ICHD - ENVIRONMENTAL HEALTH DIVISION

Statesville Office (704) 878-5305 (BB) Mooresville Office (704) 660-3625 PERMIT # AP 241155

RE: 181 Park Crest Dr

Falls Cove 669 Septic System Information

AS BUILT SKETCH

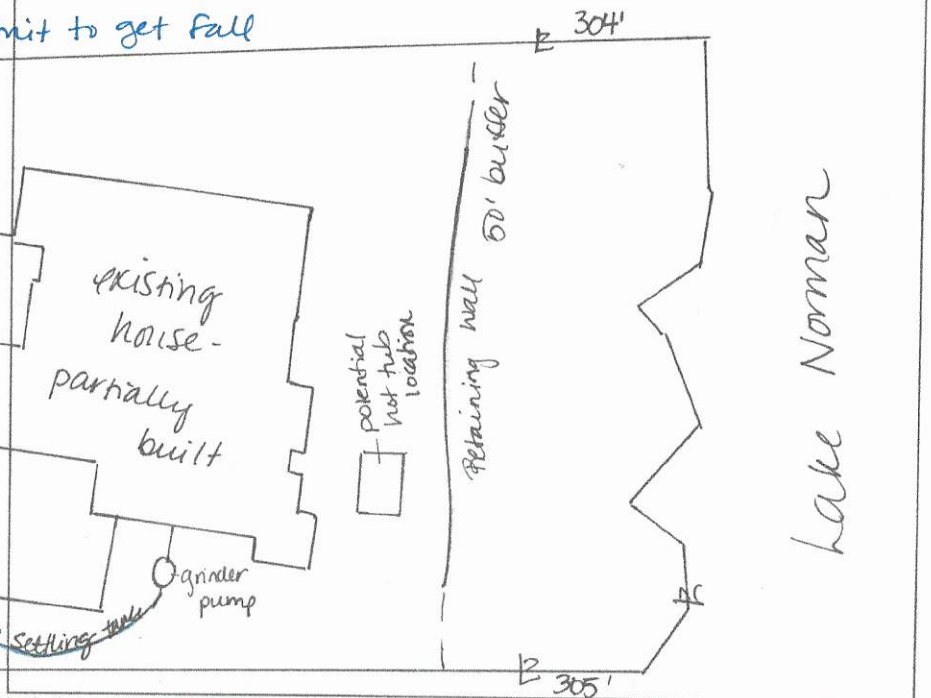
Item	Date	Initials
Drain Lines Checked bottom checked 8/31/21	8/31/21	DW
Tanks Checked	8/31/21	DW
~~Pressure Manifold or Valve Box Checked~~ D Box	9/7/21	DW
Pressure Head Set	N/A	
Electrical Checked	N/A	
Floats Set	N/A	
Alarm Checked	N/A	
Maintenance Contract Needed? Y / N		
Comments:		
all plumbing to lines 9/7/21 DW

Still need plumbing to all lines 8/31/21

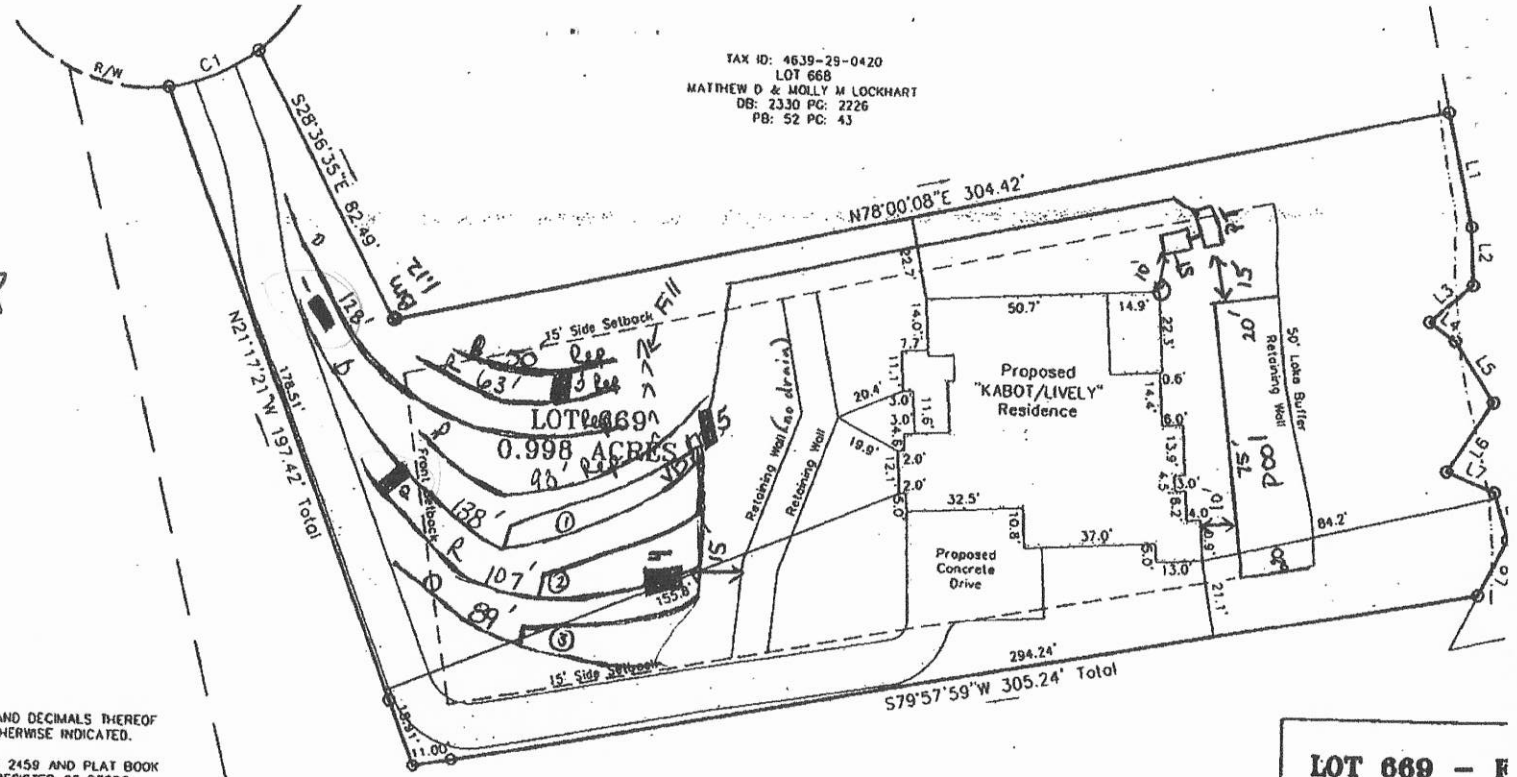
Attached is a permit completed for 4G by Kathleen Saunders in 2018. Since then, and before construction started, the homeowner added a retaining wall on lower portion and left side of the lot that I believe will prevent us from installing the repair line as shown. In addition to needing new flags set, I would like to discuss our options of moving the tank to the right corner now that the pool has been eliminated. Would it be possible to meet onsite in the near future?

You can apply for an intermediate redraw. Cost $320
